Design Review Board Meeting

Tuesday, December 10, 2024, 2:30 PM

Dear Design Review Board,
Enclosed you will find our Final Submittal for the new Archeology Research Facility at Historic Mitchelville Freedom Park. This project is part of a larger previously approved Master Plan.

**Archeology Research Facility
40 Harriet Tubman Way - Final
Plan Set
December 10, 2024
DRB-001479-2024**

7
DETAIL @ PANEL, APPLIED TRIM
3" = 1'-0"

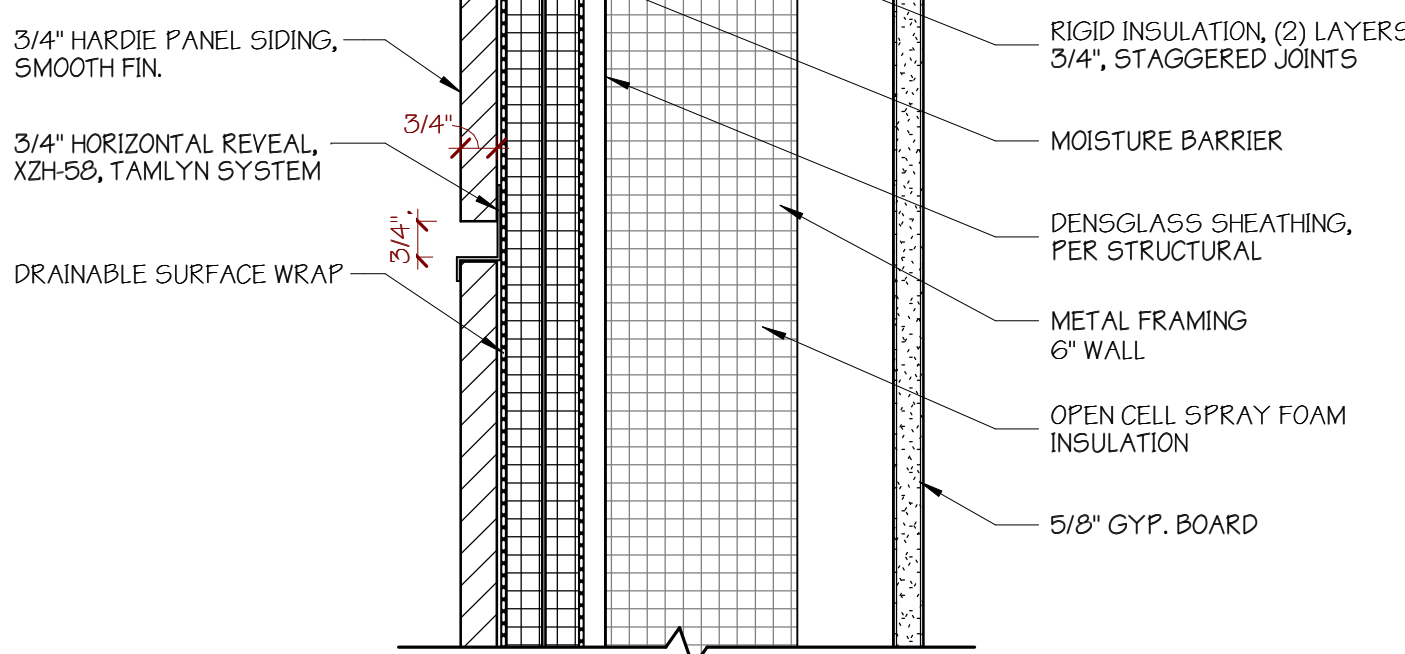
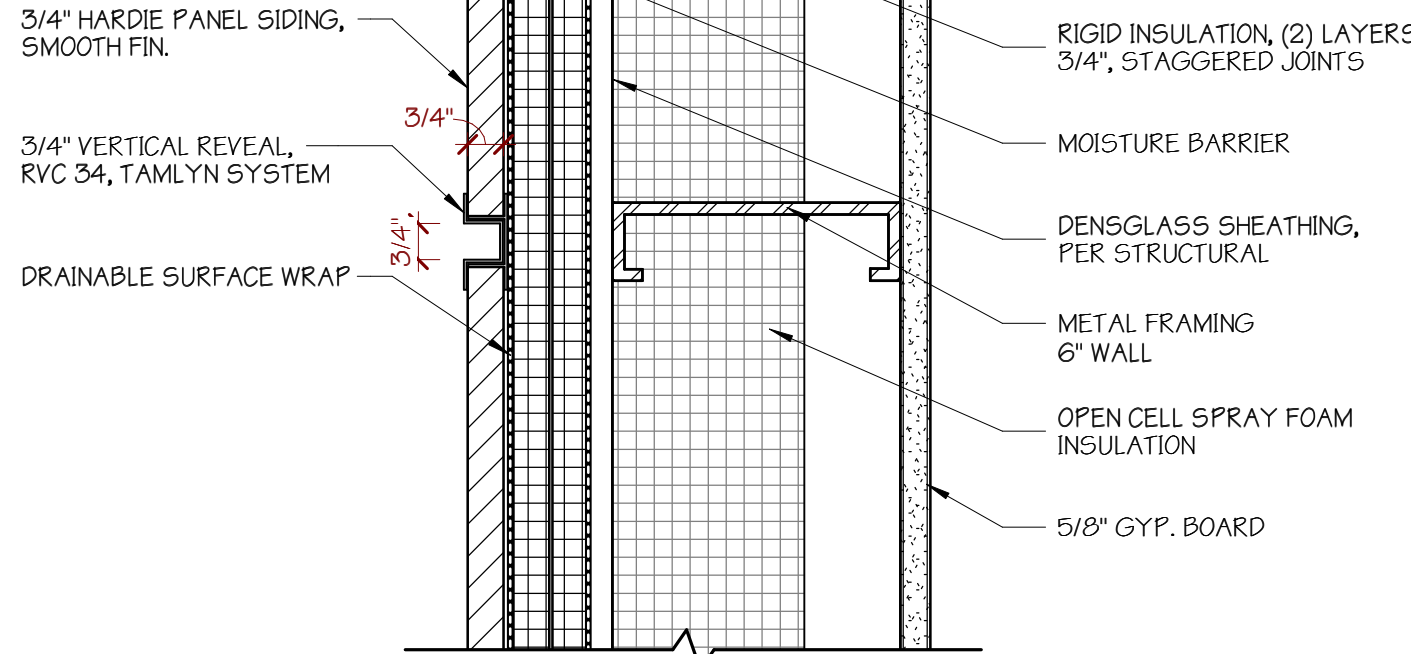
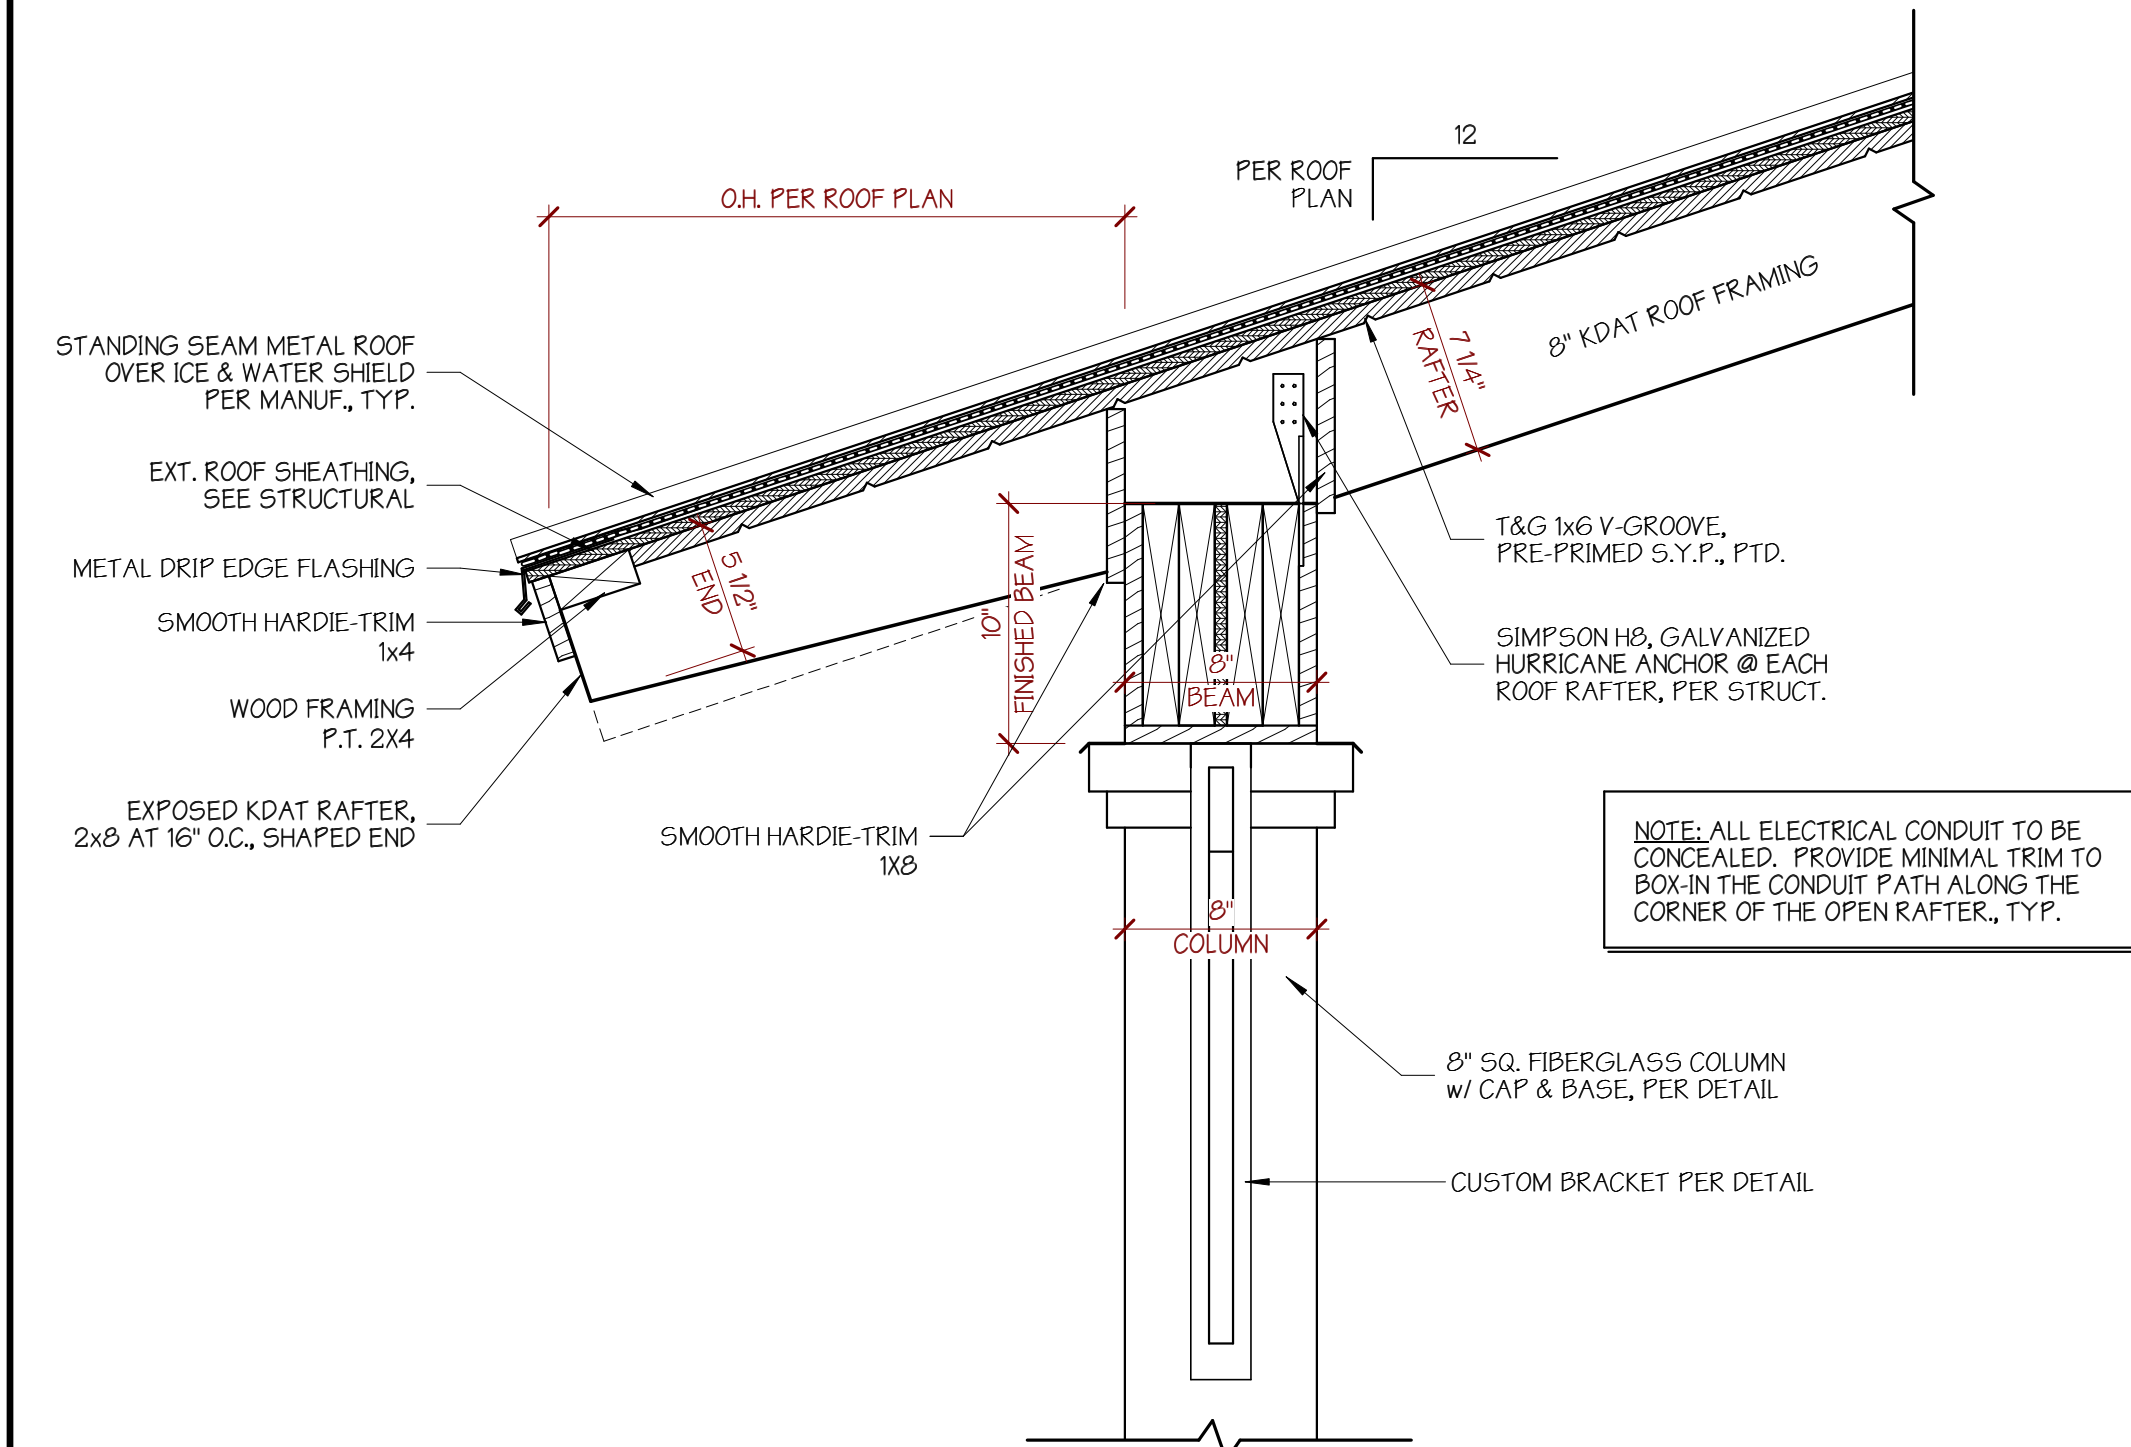
12.(ARCH) Detail of the hardie architectural panel system. *Please see the updated architectural plans.*

1
DETAIL @ SOFFIT, OPEN RAFTER 3X
1 1/2" = 1'-0"

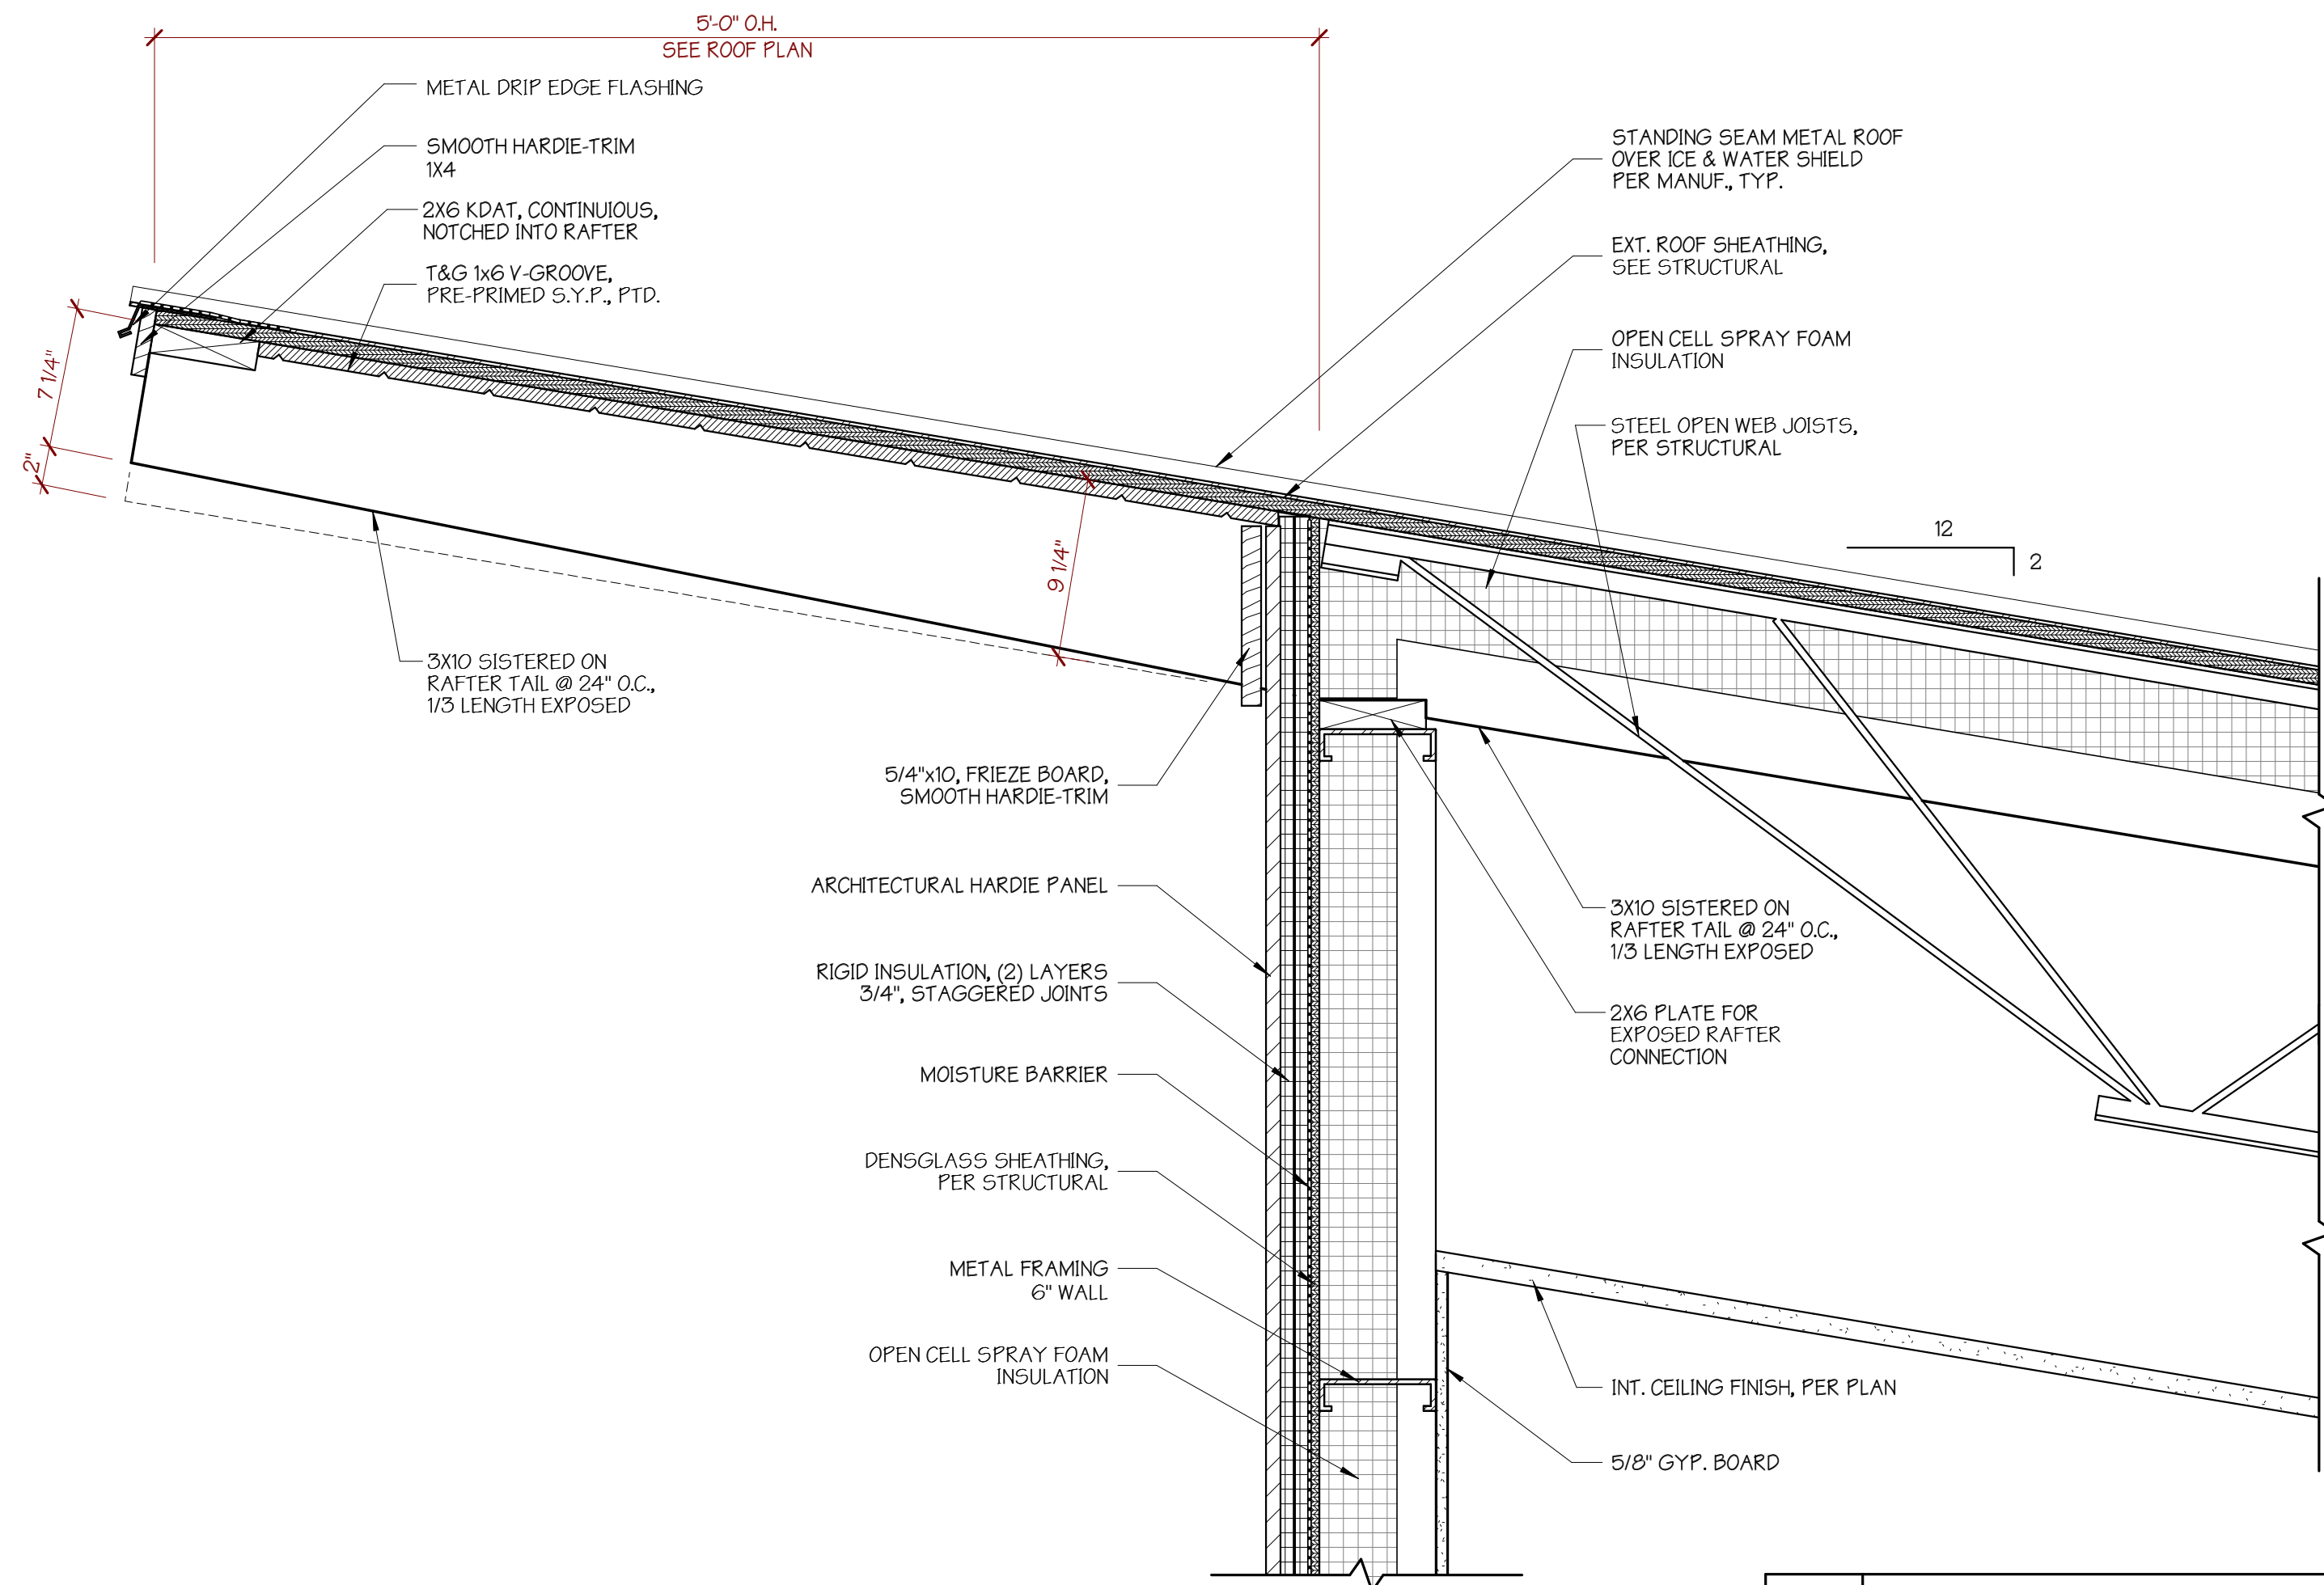
13.(ARCH) Describe how the lighting conduit will be hidden on the open rafter porch. *A note has been added to the open rafter soffit detail.*
